Sydney North Planning Panel

Panel No	2018SNH023
DA Number	LDA2018/185
Local Government Area	City of Ryde
Proposed Development	Demolition of all buildings and structures on the site and construction of a mixed use development comprising 116 residential apartment, 70m ² of ground floor commercial/retail tenancy and 4 levels of basement car parking for 136 vehicles
Street Address	9 Peach Tree Road, Macquarie Park
Applicant	Hyecorp Property Group
Owner	Various property owners of SP5991
Date of DA lodgement	9 May 2018
Number of Submissions	Four (4) submissions received against the proposal
Recommendation	Approval
Regional Development Criteria (Schedule 7 of the SEPP (State and Regional Development 2011))	Development with a Capital Investment Value (CIV) of more than \$30 Million. The CIV of this application as outlined in a detailed cost report by Registered Quantity Surveyor is \$35,110,175.00.
List of All Relevant s4.15(1)(a) Matters	• Environmental Planning and Assessment Act 1979; • Environmental Planning and Assessment Regulation 2000; • Biodiversity Conservation Act 2016; • State Environmental Planning Policy No. 19 – Bushland in Urban Areas; • State Environmental Planning Policy

Figure 13: Proposed high school building footprint as part of the Ivanhoe Estate concept plan and the subject site at 9 Peach Tree Road (ADG visual separation shown in red) (**Source:** Submission prepared by Frasers Property Pty Ltd).

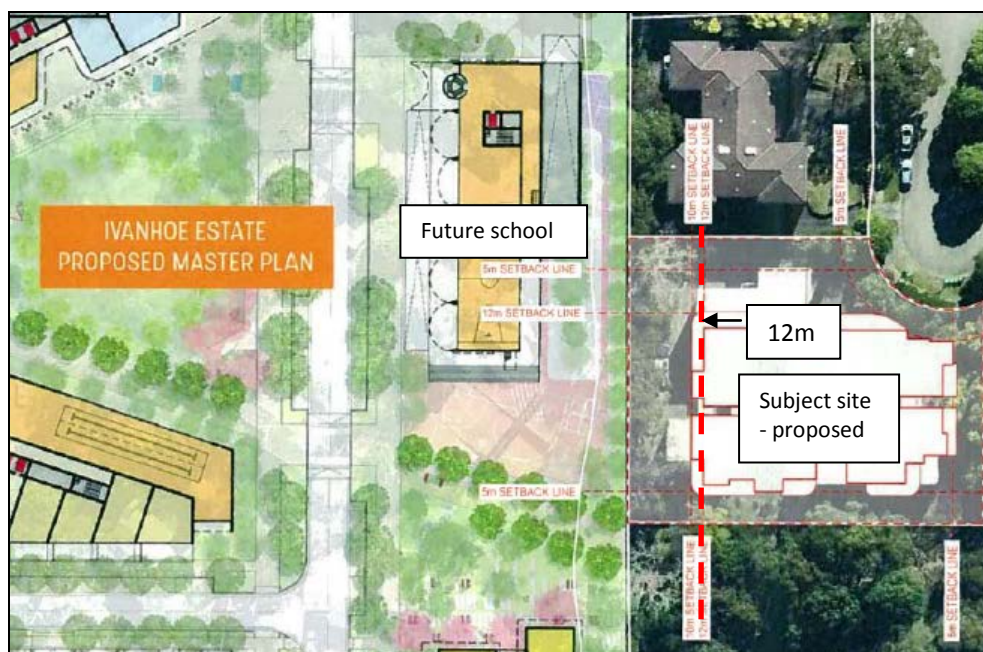
"A revised noise impact assessment should be undertaken based on the future use of the adjoining site as a school and appropriate attenuation measures incorporated into the final development.

The design of the proposed apartments on the southern façade should be reconsidered to minimise noise and overlooking impacts. In particular, any modification should reconsider the need to provide a secondary balcony that overlooks directly into the school or as a minimum enclose these balconies and add privacy screening.

Albeit the reduced visual privacy separation for the building, the proposal on its merit is considered acceptable and is recommended to be supported on the following basis:

- As noted earlier, the southern elevation of the building does not have any windows or doors that directly overlook the southern adjoining site. The provision of privacy screens has been made to avoid direct overlooking from the secondary balconies and sliding doors of bedrooms (refer to **Figure 8**).
- The building elements within the required building separation are considered to be design features that mainly serve the purpose of providing reasonable internal layout in response to the context; articulating each elevation of the proposed building by expressing the location of individual units and balconies within the building, contrasting materials and colour scheme and fenestration treatments to

- To alleviate any likely noise impact from the future school, a condition has been imposed to require a revised Acoustic Assessment report with recommendation for noise attenuation measures for the development. (see **Condition 65b**).

Figure 15: Typical floor plans of X.01 and X.08 showing the proposed change to delete additional bathroom (change in red). **Source:** From Plan DA2.08 (issue B) as prepared by Amglen Architects Pty Ltd.

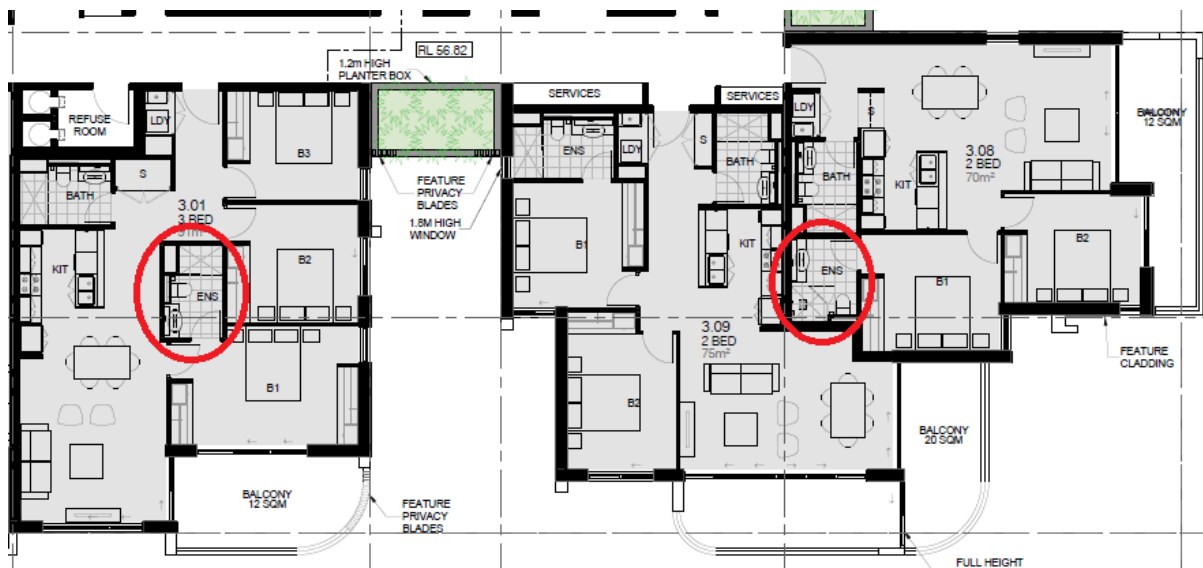
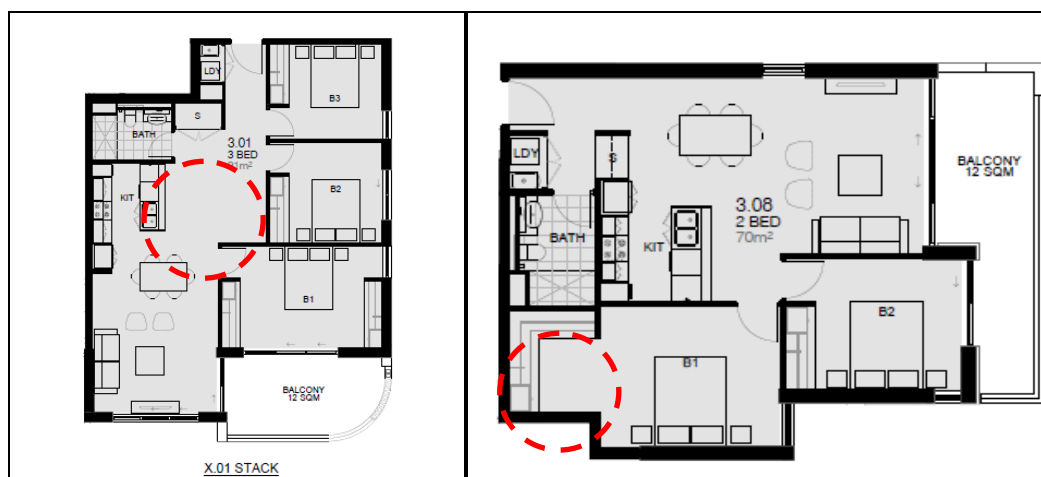
The Design Criteria state that each apartment is required to meet the minimum internal area and additional 5m² for any additional bathrooms. The development provides 25 apartments that fall short in the minimum internal area. The applicant proposes to delete the additional bathroom to comply with the minimum internal area for all 25 non-complaint apartments as illustrated in **Figures 14 and 15** below.

Accordingly, a deferred commencement condition (**Condition A1**) has been imposed to bring the proposal into full compliance with the minimum internal area under the ADG.

Figure 16: Typical floor plan showing the corridor area excluded in the GFA calculation (in red circle). The shaded areas indicate GFA at each residential floor level.

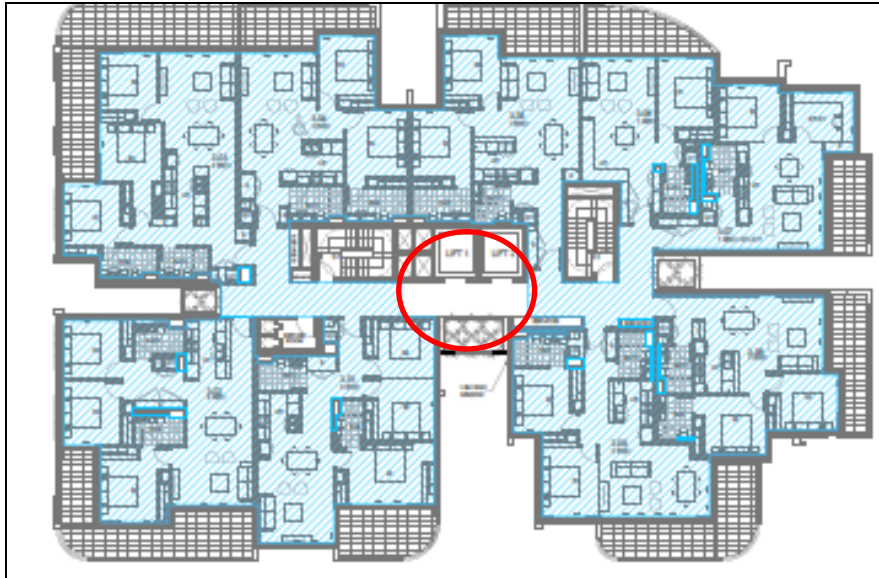
The implication of this judgement on the subject development was that the design originally excluded part of the corridor at each residential floor level as GFA because they were interpreted as external walls.

Figure 17: Height plan study submitted with Clause 4.6 variation. (Maximum building height of 45m shown in green) (**Source:** Clause 4.6 variation prepared by Architectus).

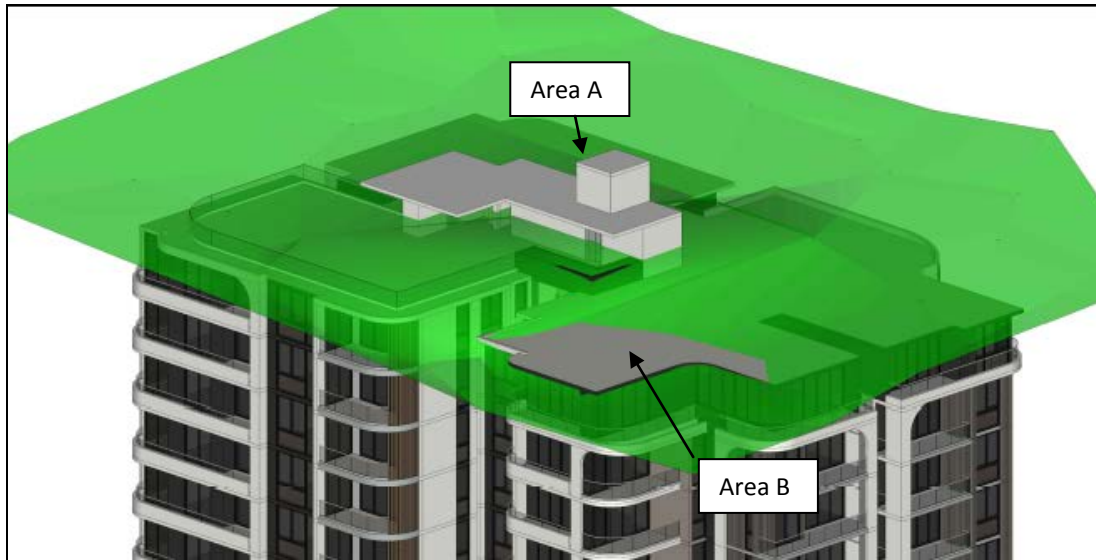
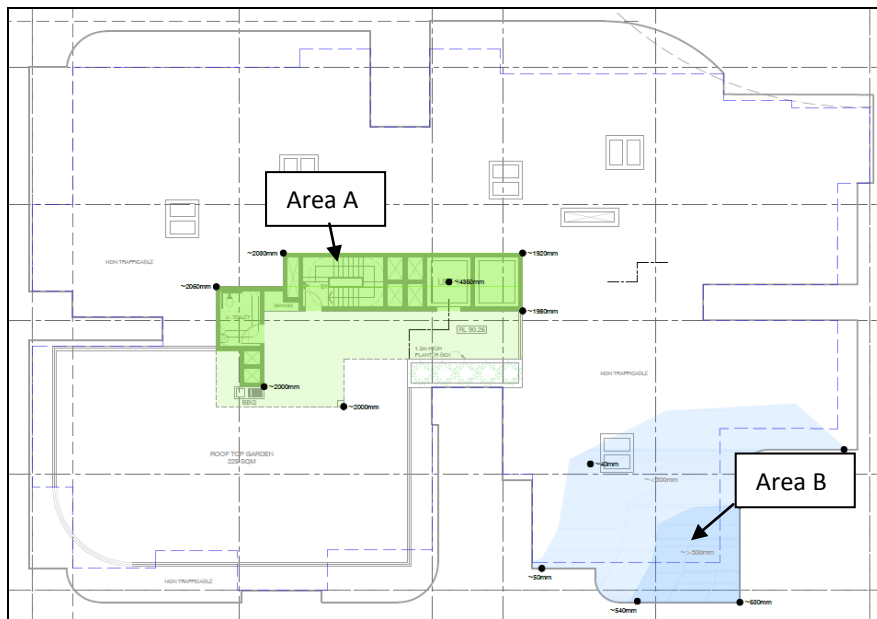
The proposal seeks a variation to Clause 4.3 – Maximum building heights under the Ryde Local Environmental Plan 2014. The maximum height of a mixed use building under Clause 4.3 is 45m above the existing ground level.

Area A: Lift overrun, fire stairs and rooftop services	Area B: South eastern corner
Maximum height	49.36m	45.63m
Permissible height	45.00m	45.00m
Exceedance height and height variation (%)	Max. 4.36m (9.7%)	Max. 0.63m (1.4%)
Total roof area = 1,032m ²		
Area of non-compliance (%) roof area non-complaint	91m ² (8.8%)	87m ² (8.4%)

The applicant's written request to vary the development standard has been considered and it is concluded that the applicant has justified that compliance with the development standard is unreasonable or unnecessary in the circumstances of the case, and that there are sufficient environmental planning grounds to justify contravening from the development standard. This conclusion has been reached for the following reasons:

- The primary height non-compliance in Area A is the result of an amendment suggested by Council to incorporate a rooftop terrace. The purpose of this amendment is to reduce the clutter of communal open spaces to the west, north and south of the ground floor level and to provide useable and functional communal open space with a direct link and access to the residential apartments. For this reason, it is considered that the rooftop terrace compares favourably to the built form with no rooftop terrace originally proposed.
